TO : All Bidders
FROM : Mark Graham
PROJECT : Rio Vista Elementary School Modernization
Project 1719800.41
SUBJECT : Addendum 1
DSA : 04-118156 / File 36-55

1. ADD ALTERNATES

SK15

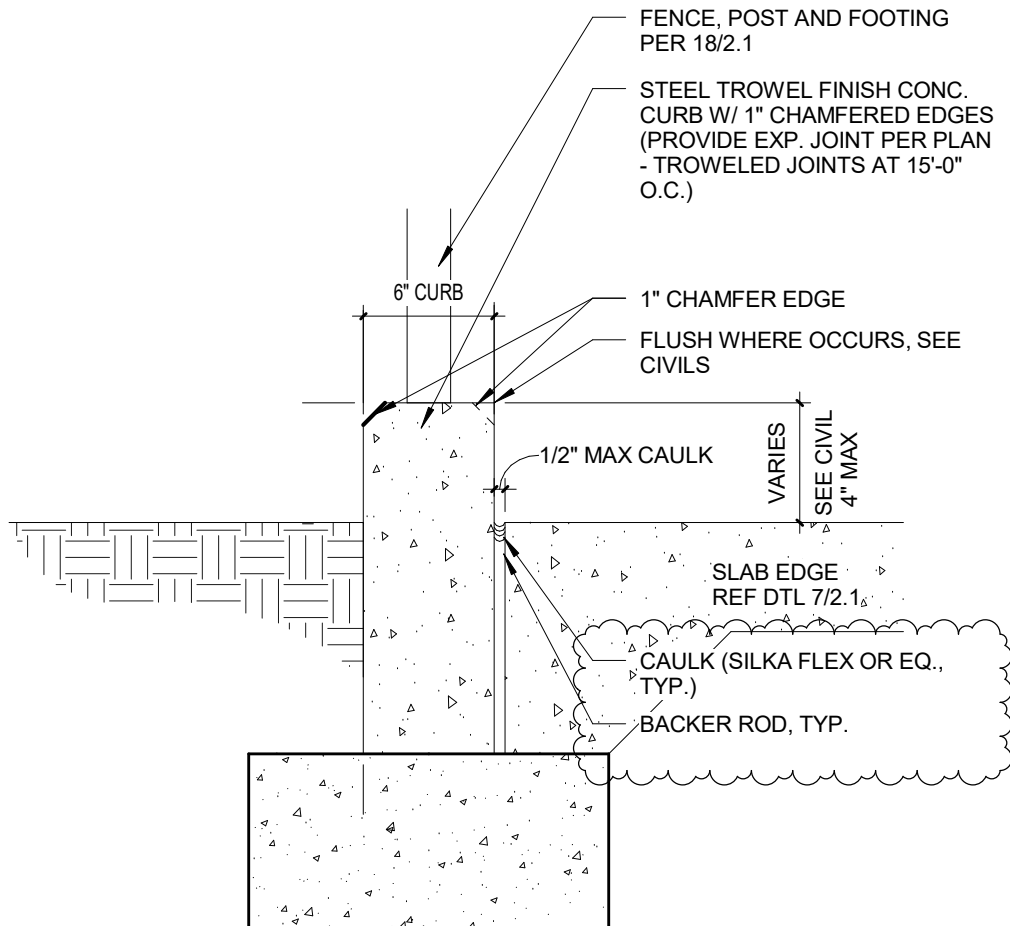
A. Detail 3

1. Replace detail with attached SK15.

SK23

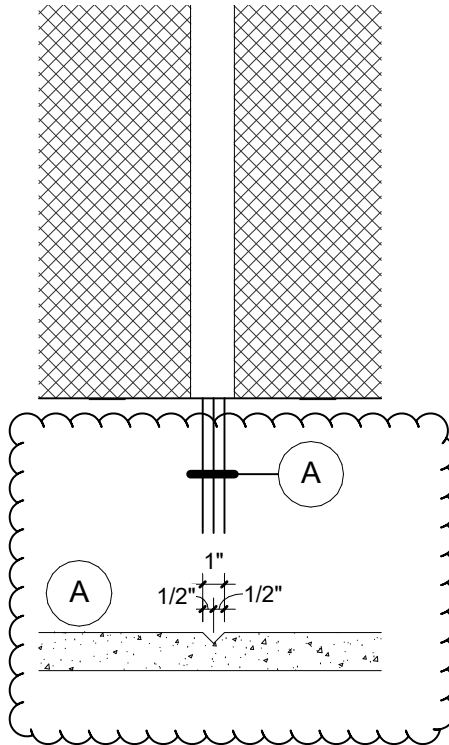
- A. Detail 4
 - 1. Replace detail with attached SK23.
- B. Detail 5
 - 1. Replace detail with attached SK24.
- C. Detail 9
 - 1. Replace detail with attached SK25.

ADD-01
SK26

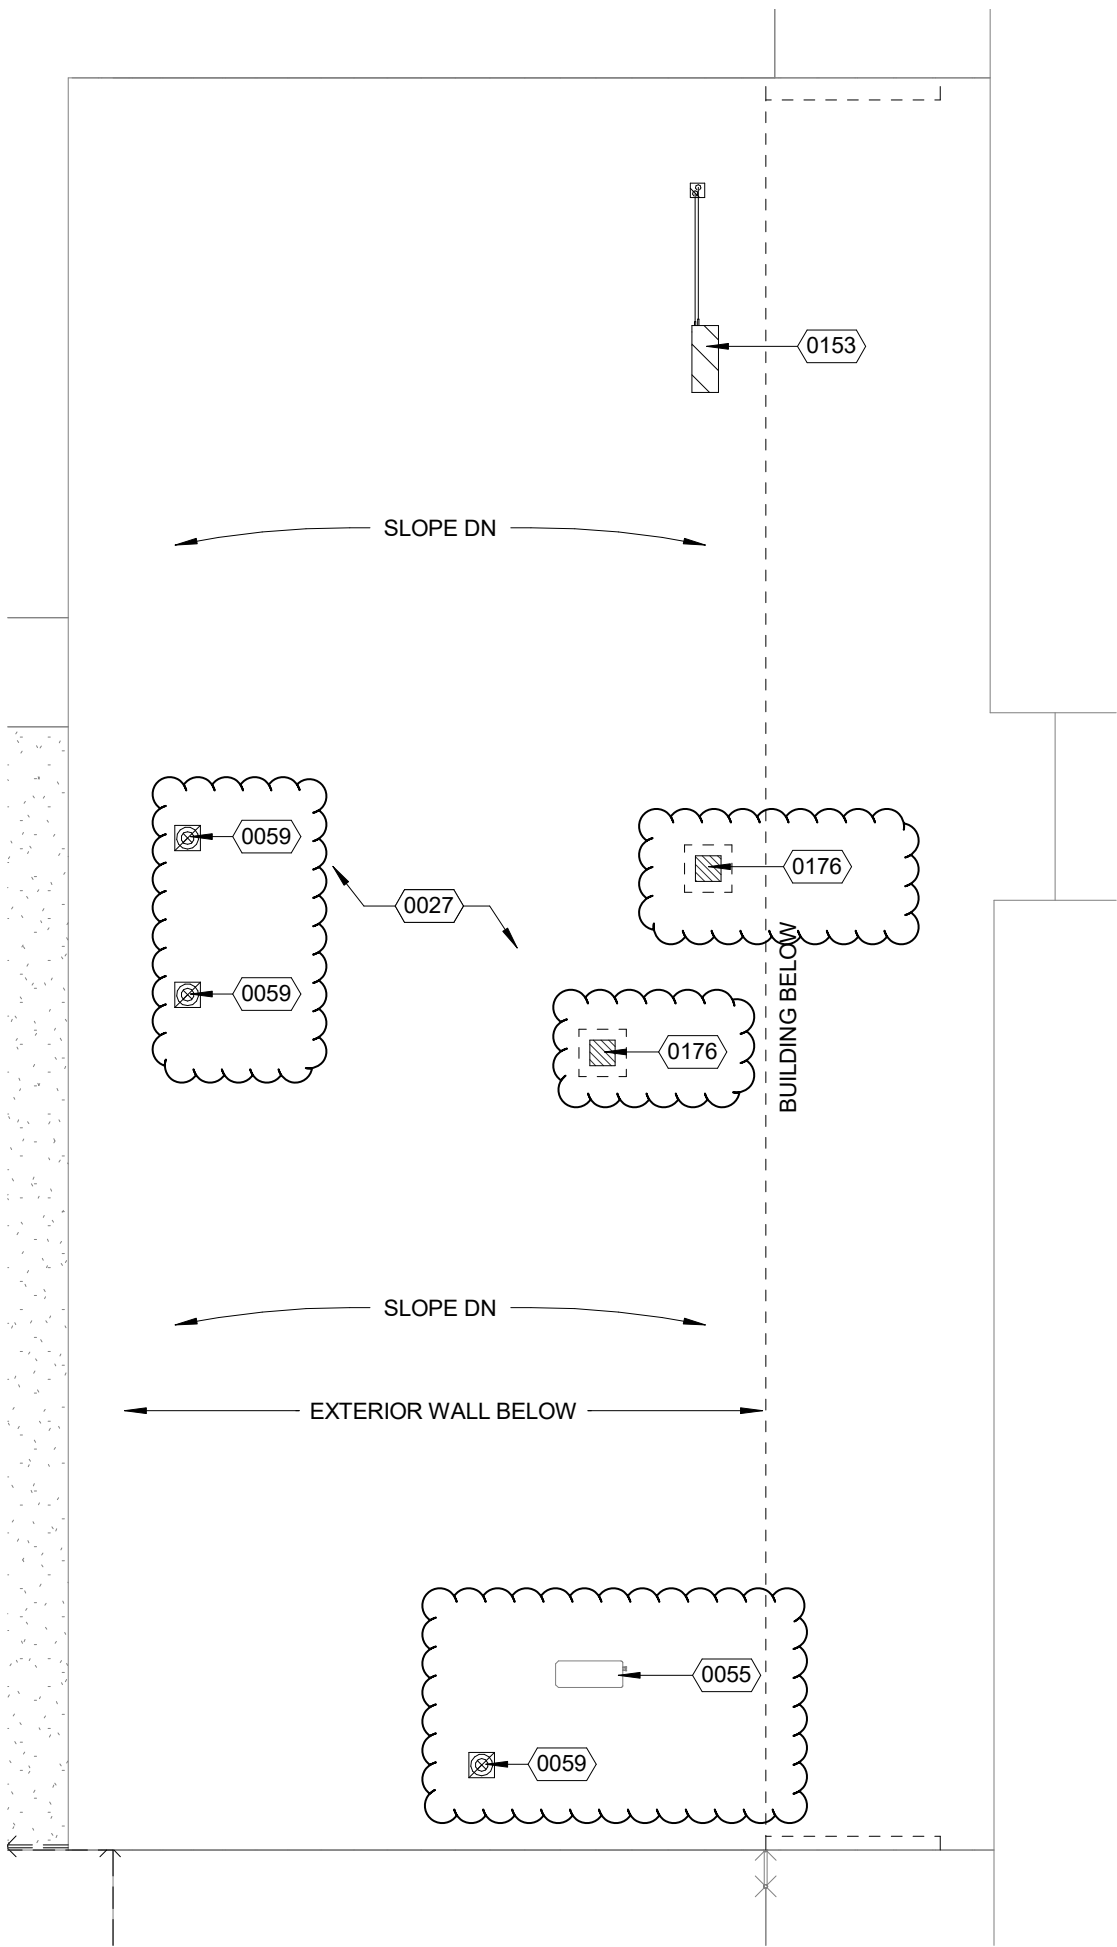
A. Detail 1

1. Replace detail with the attached SK26.

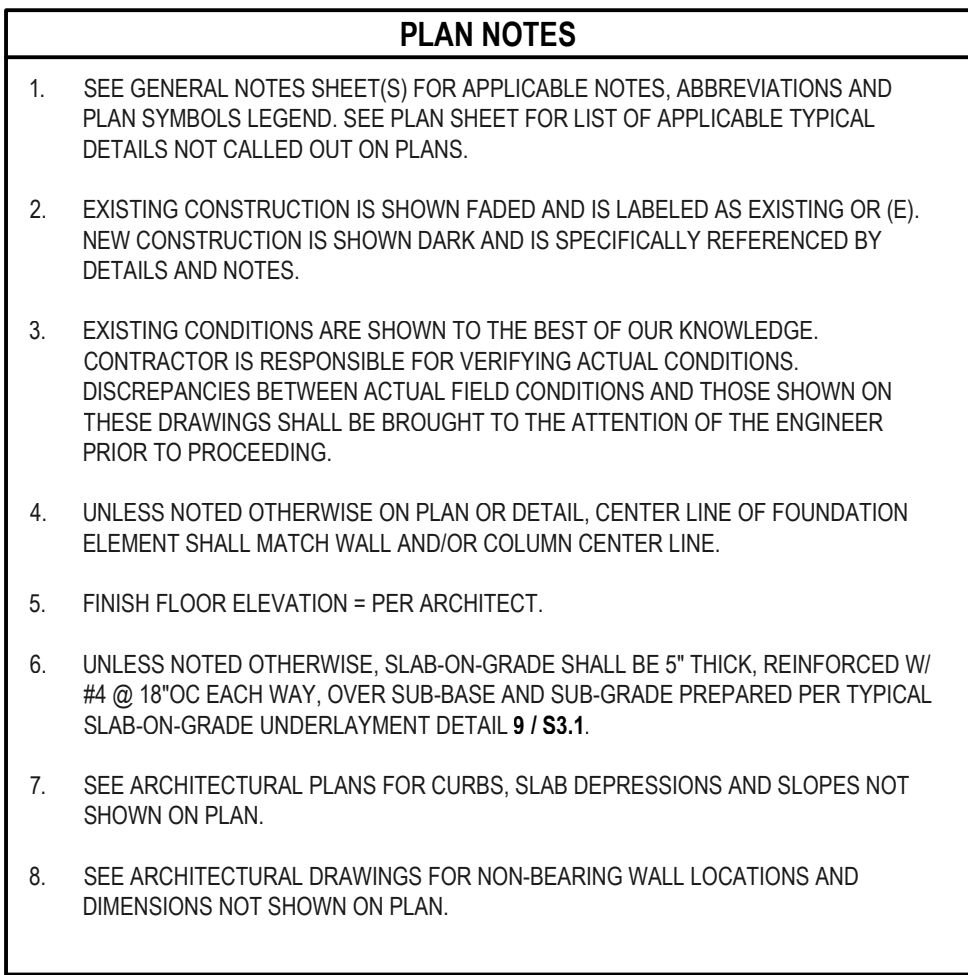
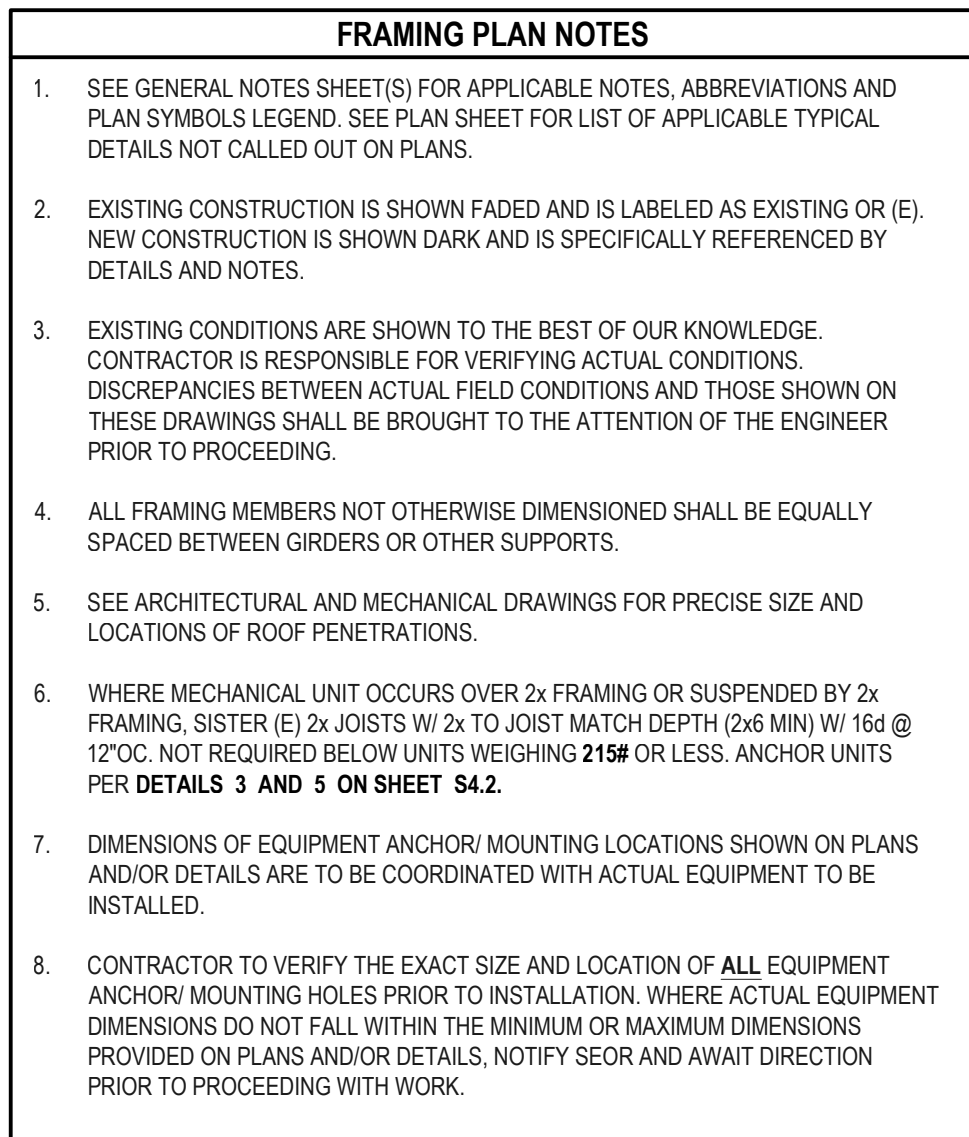
ALTERNATE NO. 2 - NO. 2 - See attachment SK27 for Add Alternate 2. This will include all landscape and irrigation improvements as shown on Landscape drawings that affect the area clouded on SK27. All irrigation, valves, timers, and plantings shall be required for remaining planter areas not called out in SK27.

THE ABOVE HATCH INDICATES THE
EXTENT OF ADD ALTERNATE NUMBER 2.
SEE DESCRIPTION IN ADDENDUM 1 TEXT
FOR SCOPE OF WORK.
